LEVY NUCLEAR POWER PLANT UNITS 1 AND 2
NRC DOCKET NOS. 52-029 AND 52-030
RESPONSE TO SUPPLEMENTAL REQUEST FOR ADDITIONAL INFORMATION REGARDING THE ENVIRONMENTAL REVIEW – HYDROLOGY 5.3.2.1-2

Levy Nuclear Power Plant Units 1 and 2
Response to NRC Supplemental Request for Additional Information Letter
Regarding the Environmental Review, dated June 23, 2009

NRC RAI #: 5.3.2.1-2

Estimated Thermal Plume Simulation
ΔT-Winter-Low Water Slack
FIGURE 5.3.2.1-2C

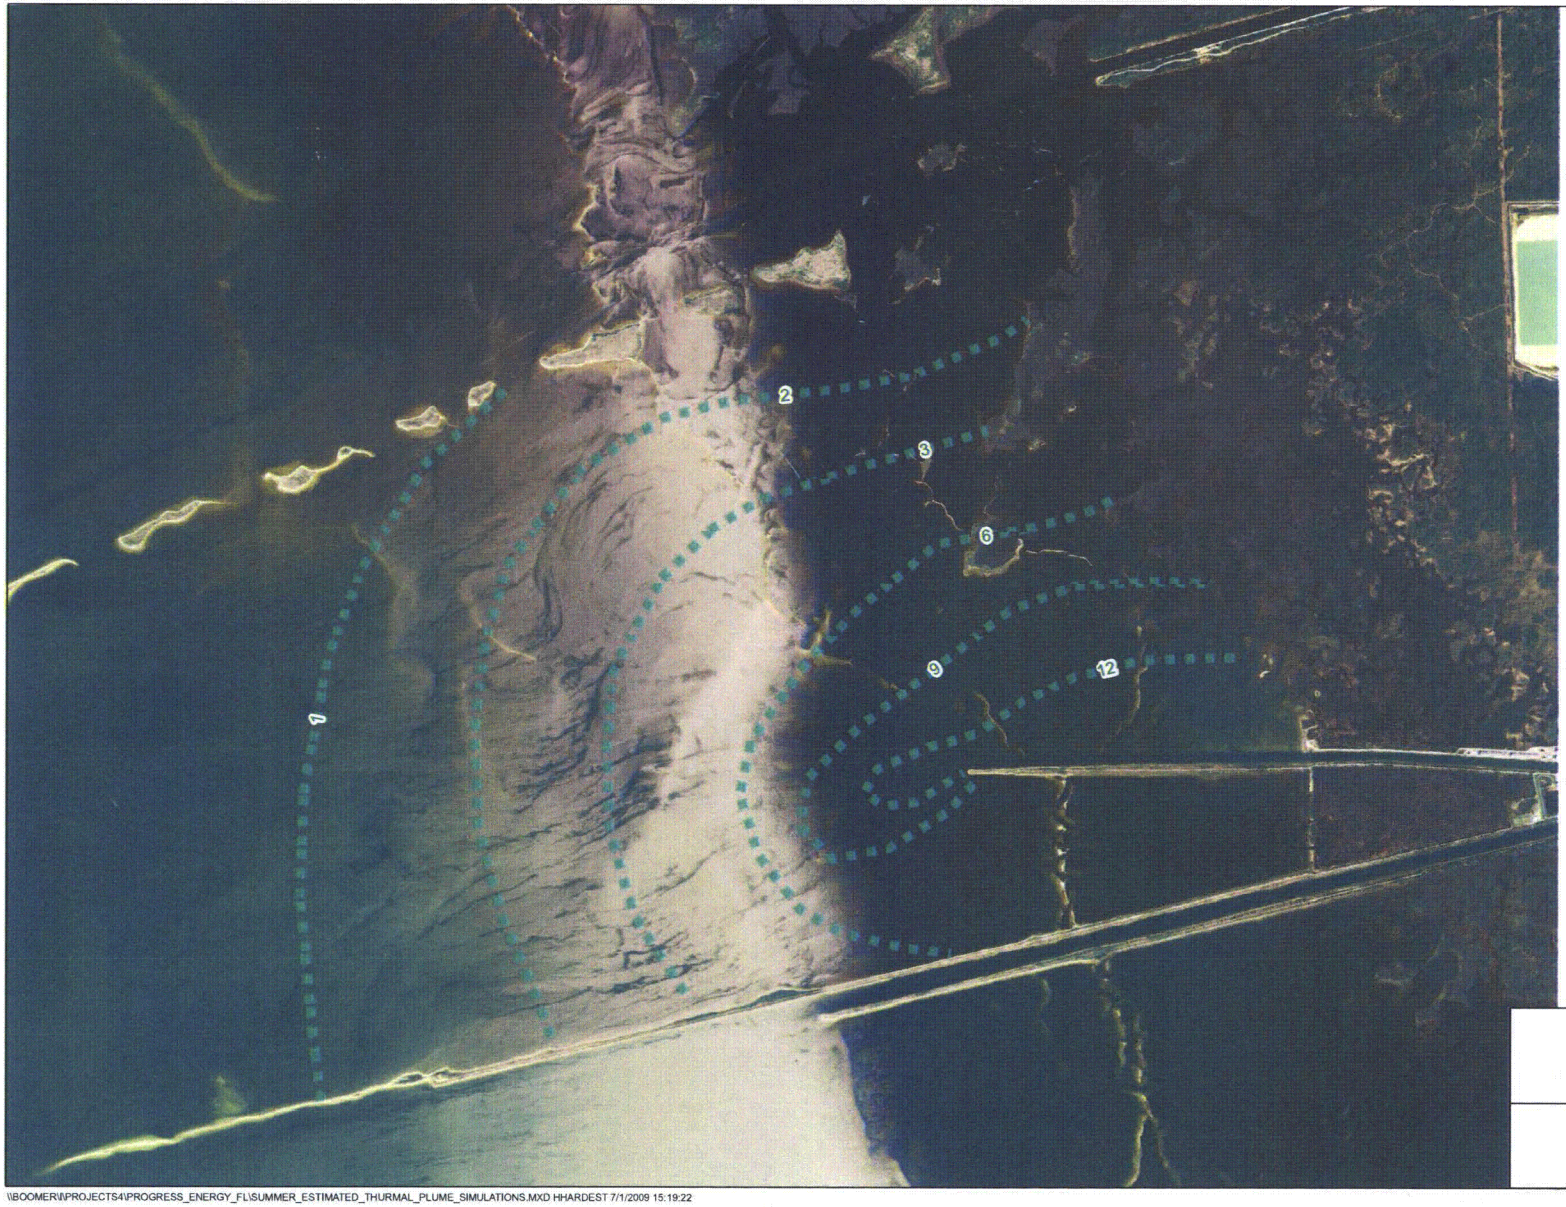
8. Figures showing the extent of the effluent plume in the Gulf of Mexico along with the dilution contours (a) before the addition of the LNP discharge and (b) after the addition of the LNP discharge.

The permitted maximum CREC discharge temperature is 96.5°F (3-hour rolling average) and the high design Gulf of Mexico intake water temperature in August is 91°F, for a differential temperature of 5.5°F. For summer conditions under the design conditions, the isotherms from the 1985 316 Studies were modified for the lower discharge temperature differential by fitting an exponential decay function and then lowering its starting value from 16.7°F to 5.5°F. This modification, as shown in Attachment 5.3.2.1-2D, results in a smaller temperature gradient for the thermal plume than what was shown in 1985 (ER Reference 2.4-083). The areal extent of the summer plume is somewhat smaller than the winter plume, so the winter plume would represent the largest footprint of the thermal plume.

Since the impact of the LNP's small increase in flow and salinity is predicted to be negligible in the near-field, any change in the footprint of the plume is also expected to be negligible and within the accuracy of the plots developed from the 1985 316 Studies. Near-field simulations predicted that the plume would be only about 13-meters different (narrower) 50 meters offshore. The far-field mixing (from Gulf currents, wind, etc.) would not be changed substantially by this small difference and it would be hard to visually discern this difference at the scale necessary to plot these results. Therefore, separate plots were not produced for post-project scenarios because the same ones shown in Attachments 5.3.2.1-2C and D would apply.
